PLANNING UNIT REPORT
DEPARTMENT OF PLANNING AND DEVELOPMENT
January 16, 2007

**FINAL PLAT/REVISED PRELIMINARY PLAT OF "THE AMERICAN CENTER PLAT
- HANSON FIRST ADDITION" LOCATED AT 4698 EASTPARK BOULEVARD:**

SUBJECT: American Center Plat Hanson First Addition Final Plat (4698 Eastpark Boulevard)

THE AMERICAN CENTER PLAT HANSON FIRST ADDITION

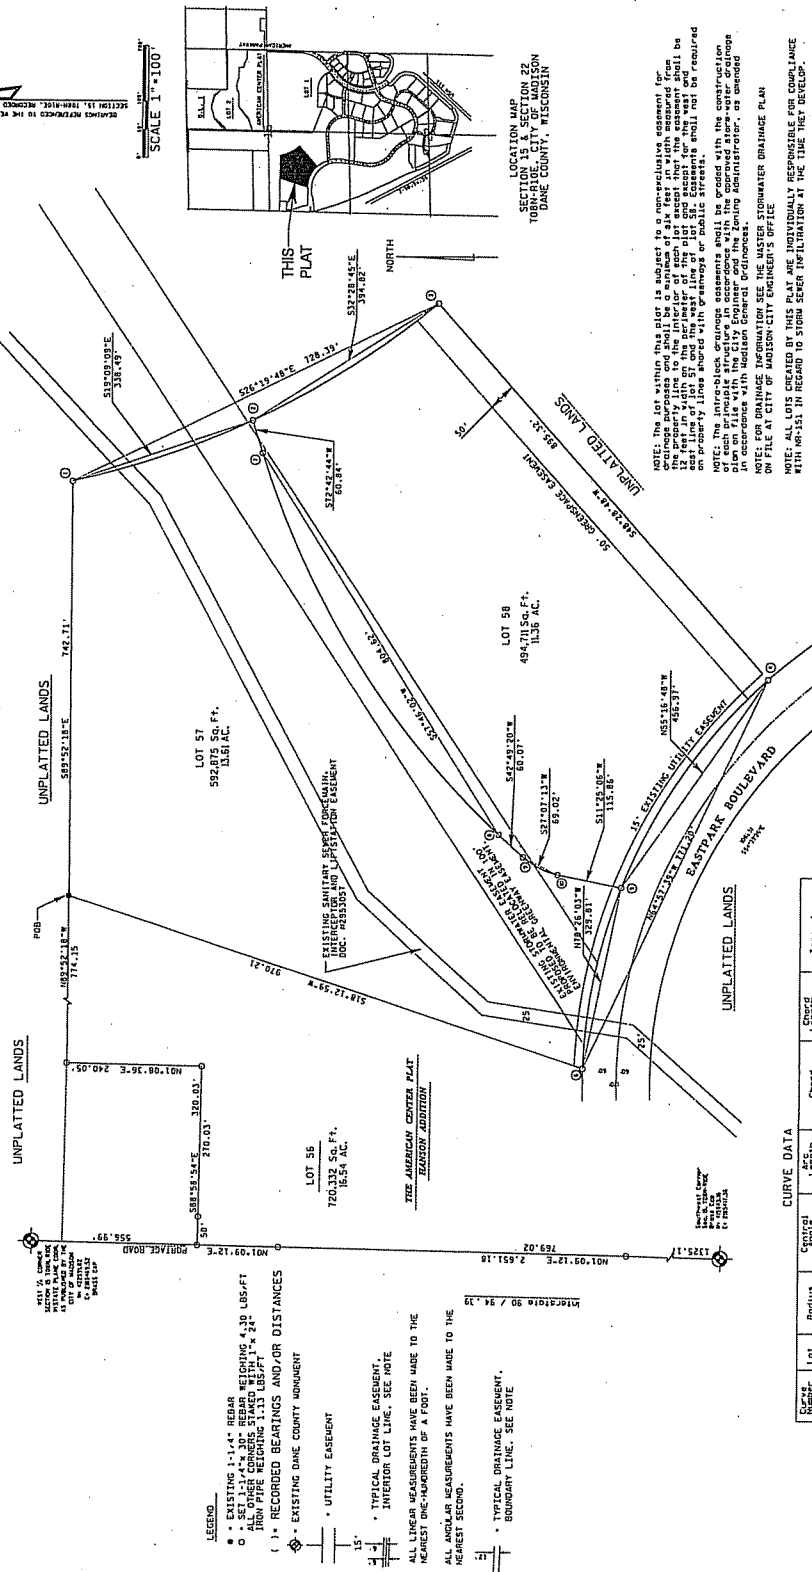
1. Southeasterly line of Lot 58 erroneously truncates at the existing utility easement and not the Eastpark Boulevard right-of-way line. Revise accordingly.
2. The Developer shall construct Madison Standard Street Improvements for Eastpark Boulevard.
3. Applicant shall dedicate public storm easement for piped/relocated greenway.
4. Prior to approval, and as part of the Master Plan for Stormwater Management, applicant shall provide evidence that the lot shall not flood/overflow during a 100-year rain event.
5. Applicant shall provide sanitary sewer easements (15-foot wide minimum) for proposed sanitary sewer relocation.
